802 PINE

#3024239

FEB 6 2018

DRB RECOMMENDATION MEETING

GROUND FLOOR PLAN: 3D

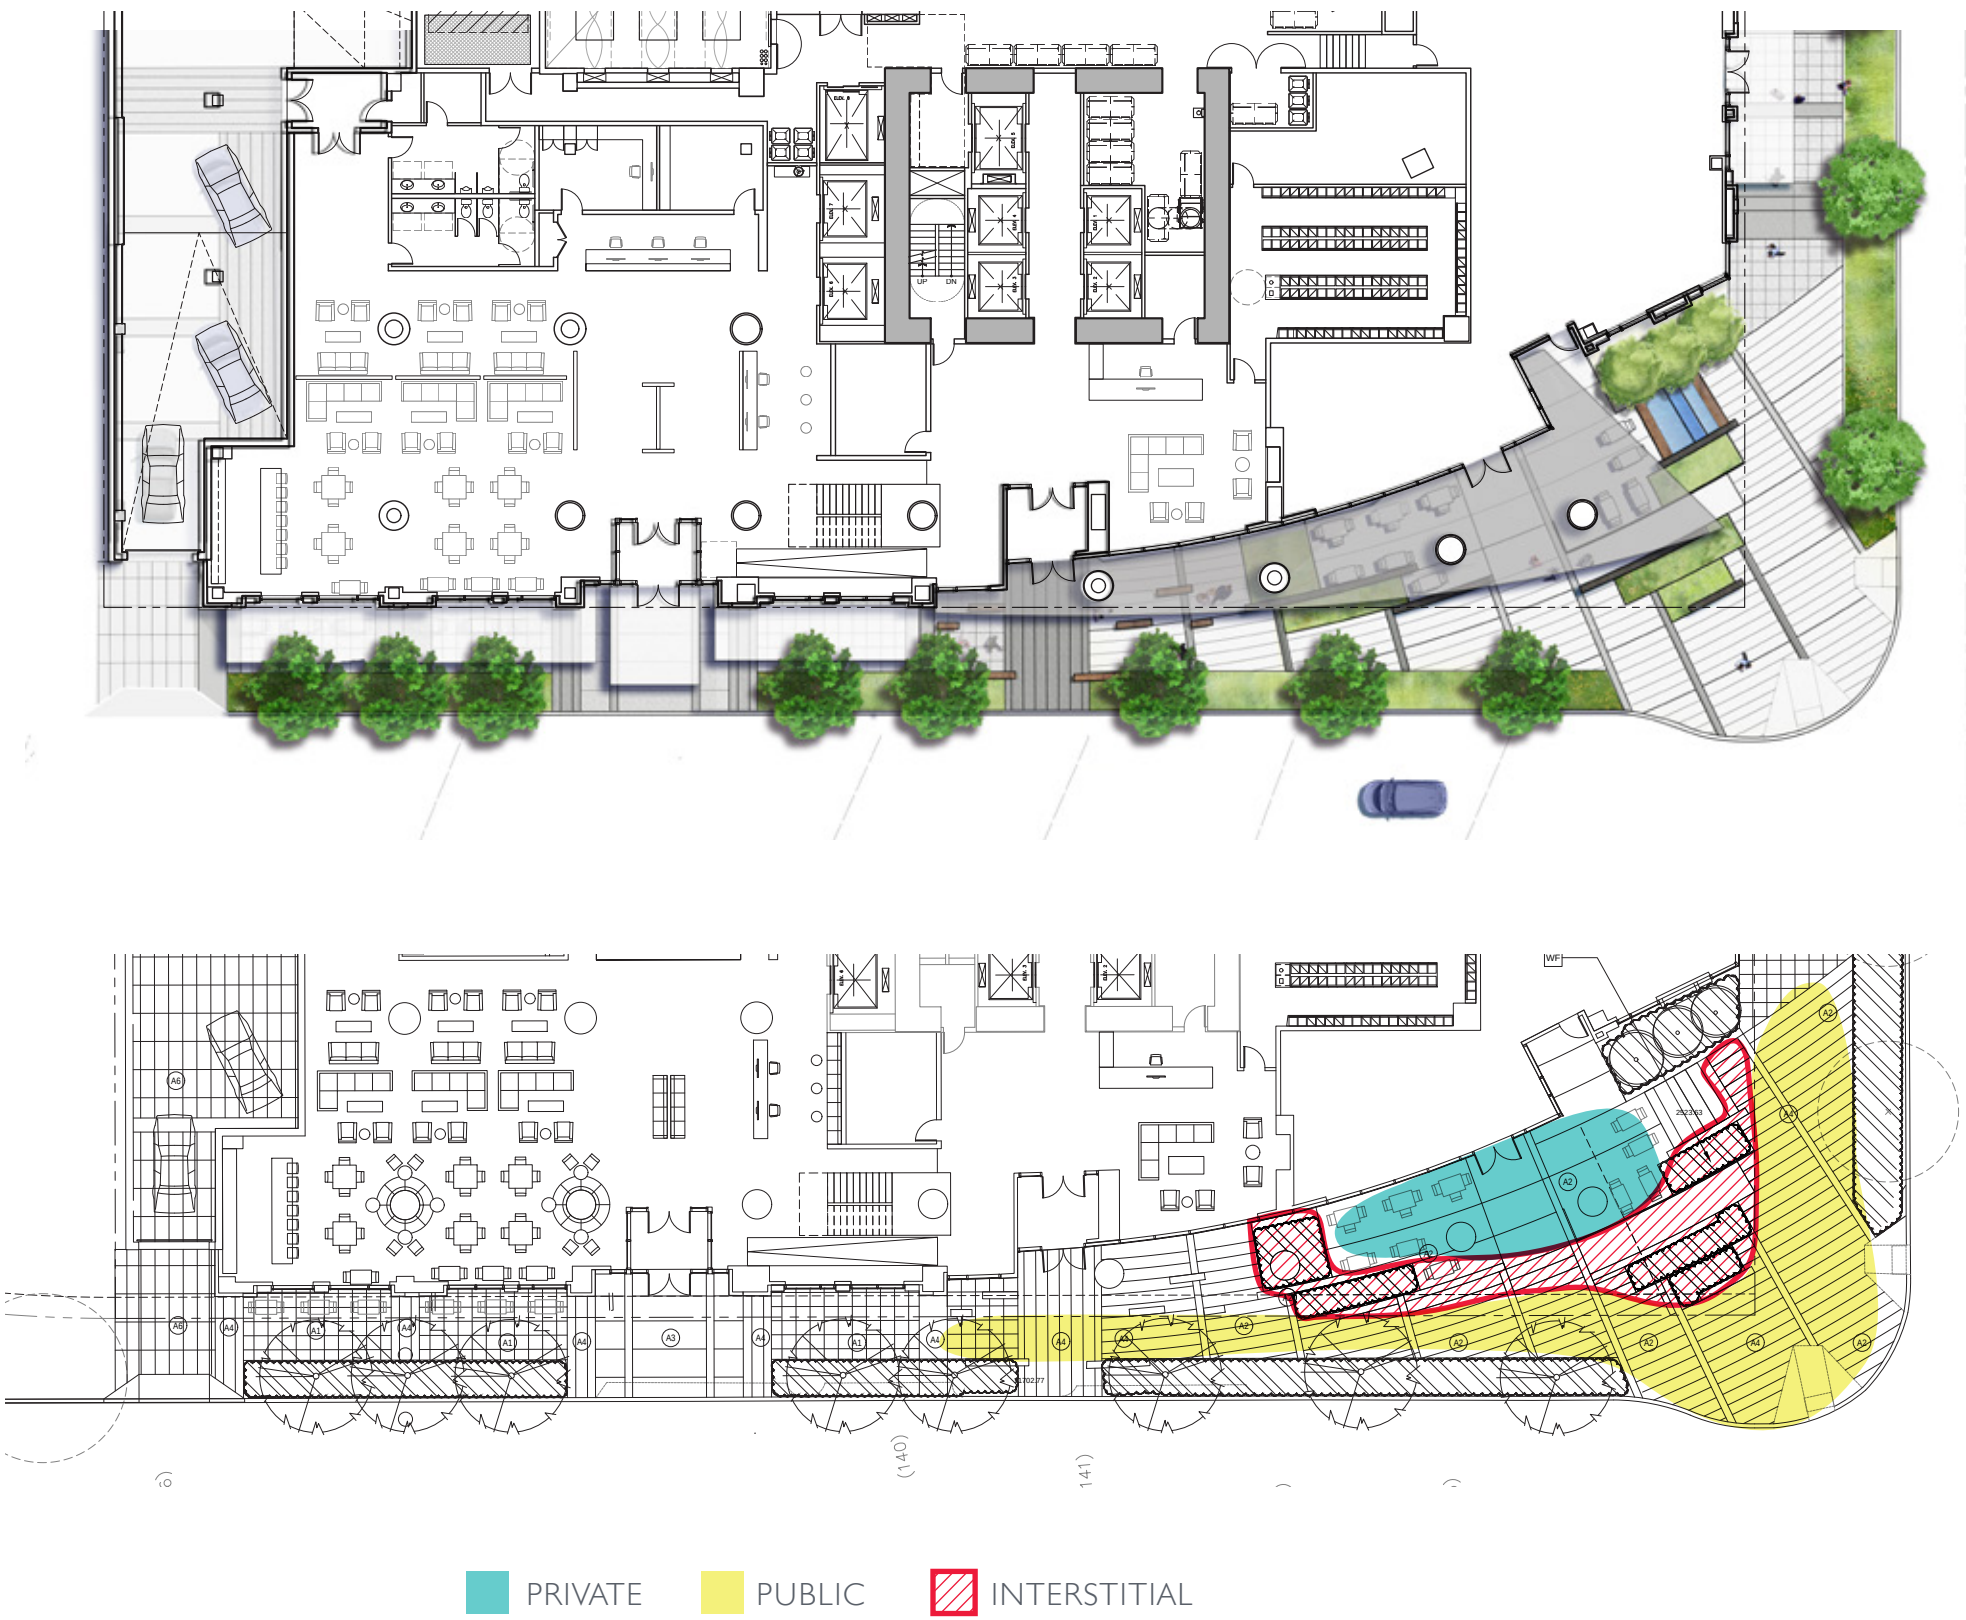
3d. The Board supported the proposed landscape and paving design shown on pg 59, including the radial pattern that reinforces the curve and generous plaza setback at the south west corner. The Board agreed that a portion of the plaza adjacent to the storefront could provide activating café seating for the adjacent tenant, and multiple doors should be provided and shown. The Board agreed that private zone should not extend to the corner property lines, and space at the corner should be reserved for the pedestrian desire lines of the general public to ease around the corner.

Response : The design team has worked to develop a three tiered “zoning” of spaces, which works with the topography to help blend the zones into a cohesive whole.

The proposal keeps the “private” zone for outdoor seating and cafe spill out spaces as a defined area.

The pure public zone, primarily the sidewalk outside of the property line is also maintained and enhanced with landscaping.

The third tier is the binding agent between the two. This interstitial semi-public (private property, but implied public use) space addresses the fairly dramatic grade change around the 8th and Pine corner with walls, planters, a water feature, and ramps. This space provides a buffer between the public and private zones, while allowing the public to cut the corner on 8th and Pine, away from the busy intersection. The landscaping also blends seamlessly into the public and private zones, tying them all into one cohesive design strategy.

FACADE MATERIALITY AND COMPOSITION: 4A

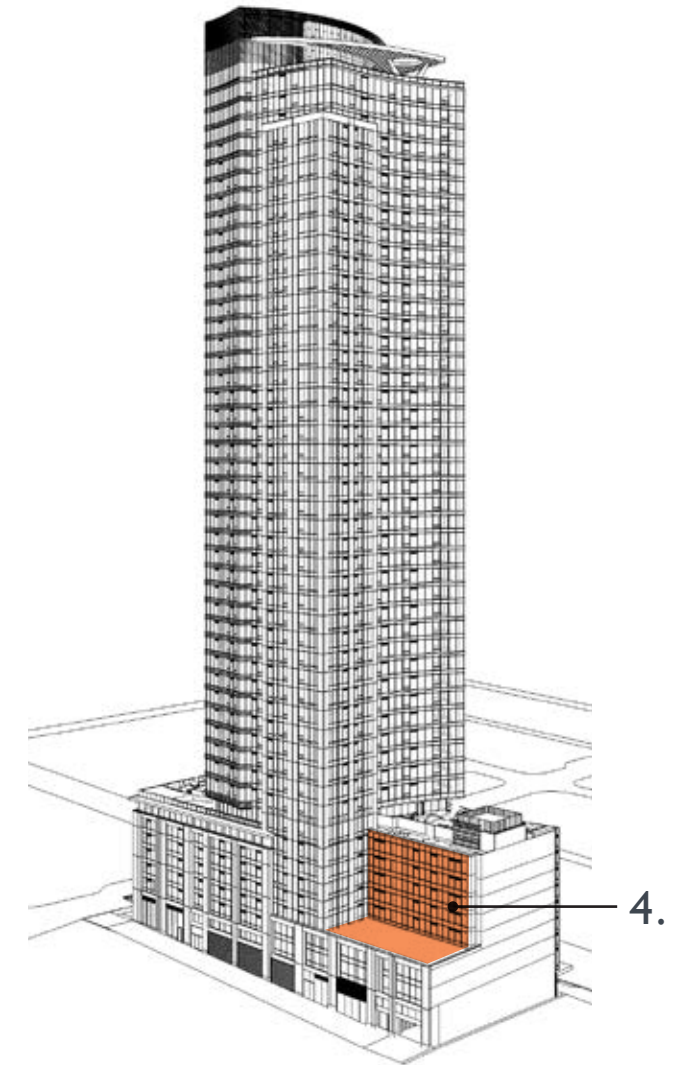
4a. The Board recommended resolution of the massing of the tower and how it connects to the two podiums (2a, 2b above), which are massing priorities before addressing the façade composition of the building. (B-4; C-2)

Response : The massing of the tower improves the relationship between tower and podium in several ways:

1. The podium setbacks are removed on the frontage streets, and positioned at the alley. This allows the tower massing to slip by and interact with a more robust podium.
2. The strong vertical element at the tower's southwest corner anchors the tower to the street.
3. The secondary element at the tower's northwest corner slips into the podium, but vertical and horizontal reveals allow this piece to be read horizontally as well as vertically, giving it a secondary presence and hierarchy to the southwest corner.
4. At the alley, the podium sets back, allowing more of the tower to slip by, elongating the tower so that it appears slimmer. The podium setback also respects the neighboring building to the north and The Camlin hotel across the alley, providing distance and separation from those structures.

FACADE TYPE LOCATION DIAGRAM

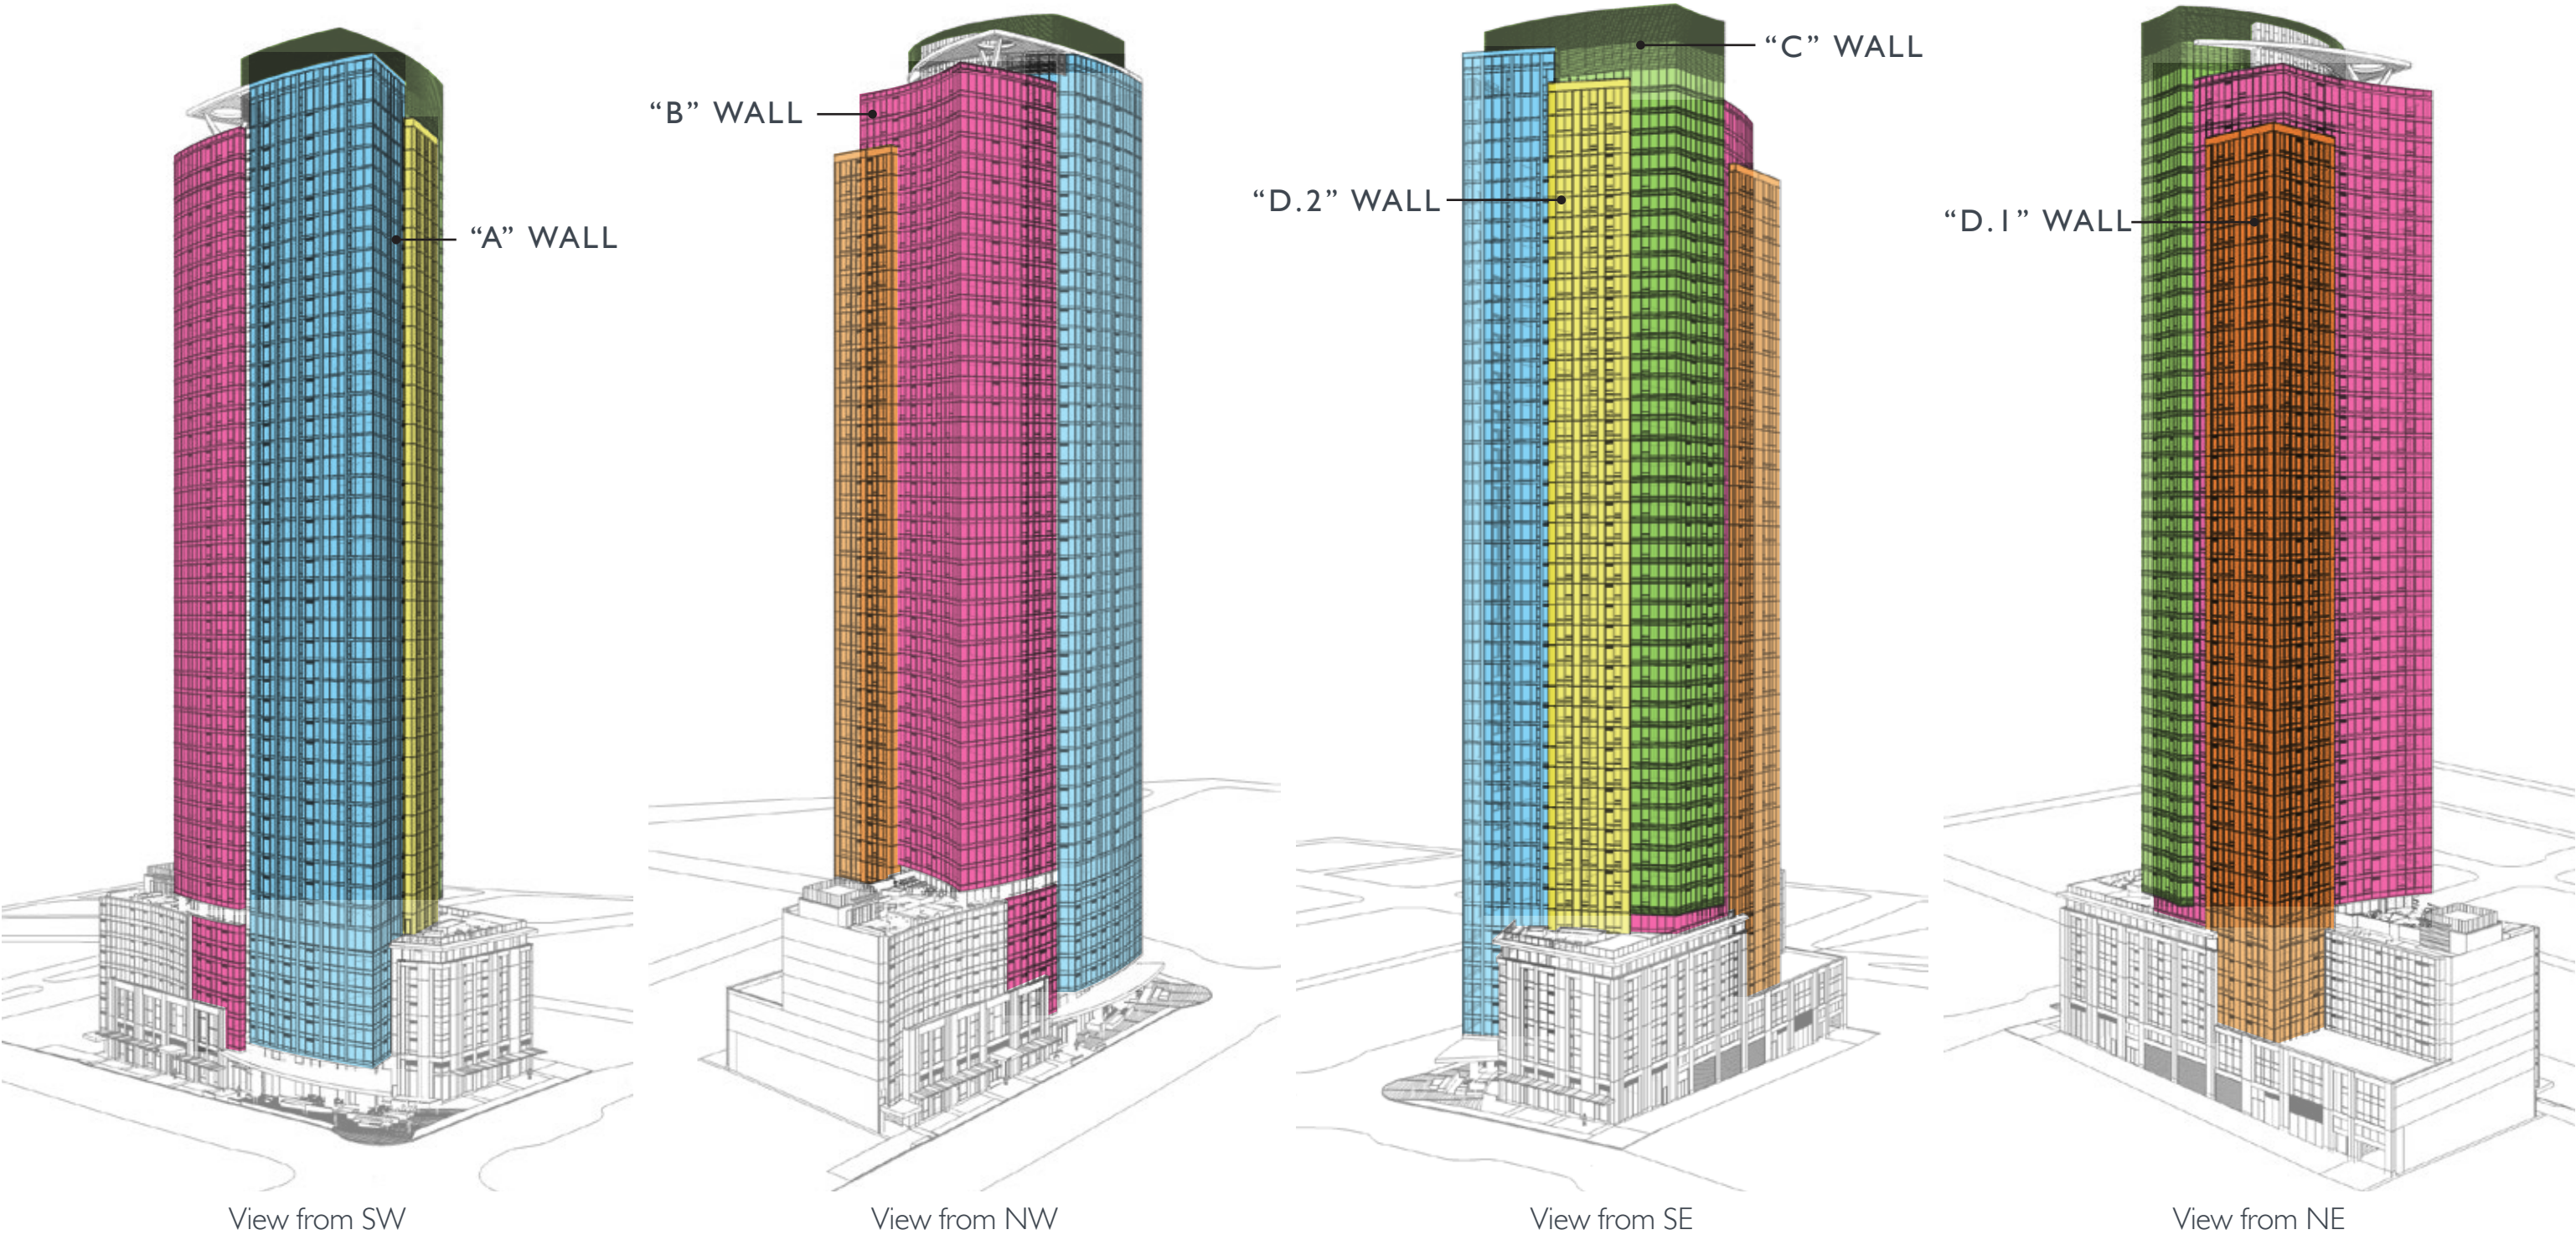
4b. The Board strongly suggested the exploration of façade materials that are cohesive but not blandly uniform, and not relying upon staggered or randomized patterns which are currently overused. The Board also recommended some façade articulation and relief on the long south-east facing wall of option 3, but that does not mandate faceting or other drastic plan moves. (A-2; C-2; C-6)
